**TB 180**

## **TECHNICAL BULLETIN**

**Product :** Midilift (SL, GL, SLplus & XLplus)

**Subject :** Introduction of new Label Neptis closer (used on Midilift swing landing gates and fire doors)

**New Programmer (Stannah ref: 9449097).**

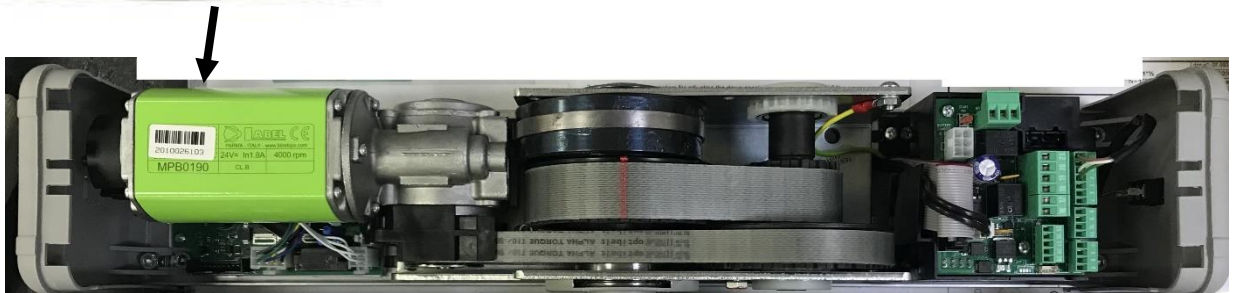
The Label Neptis LET power door closer (Stannah ref: 6103831) has been made obsolete and has been replaced by the Label Neptis Plus NB-LET (Stannah ref: 6104112).

With this change Label have introduced a new handheld programmer which is NOT backwards compatible with the previous model.

Identified by the green leaf on the top right-hand corner, can **ONLY** be used with the new Label Neptis Plus NB-LET power door closer (**Stannah ref: 6104112**) identified by the green motor.

The new programmer (Stannah ref: 9449097) can be ordered through Stannah lifts spares department.

**Old Programmer (Stannah ref: 9449093).**

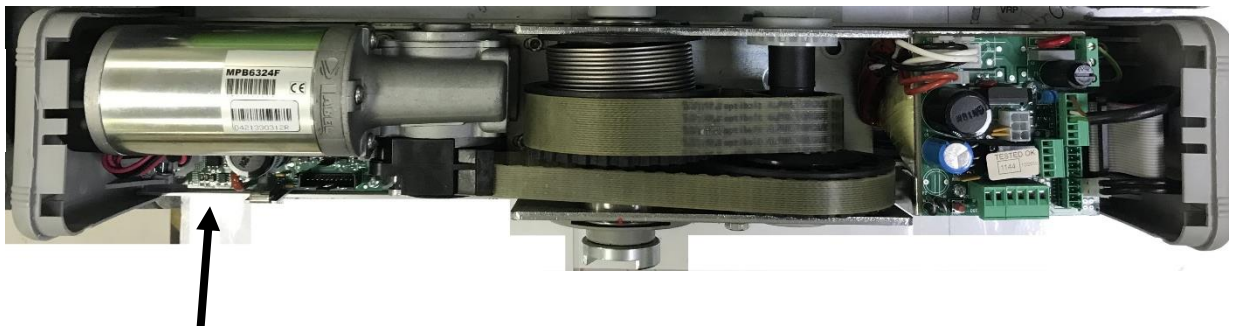
Identified by the  $\text{m}$  symbol on the top right-hand corner, can **ONLY** be used with the old Label Neptis LET power door closer (**Stannah ref: 6103831**) identified by the non-green motor.
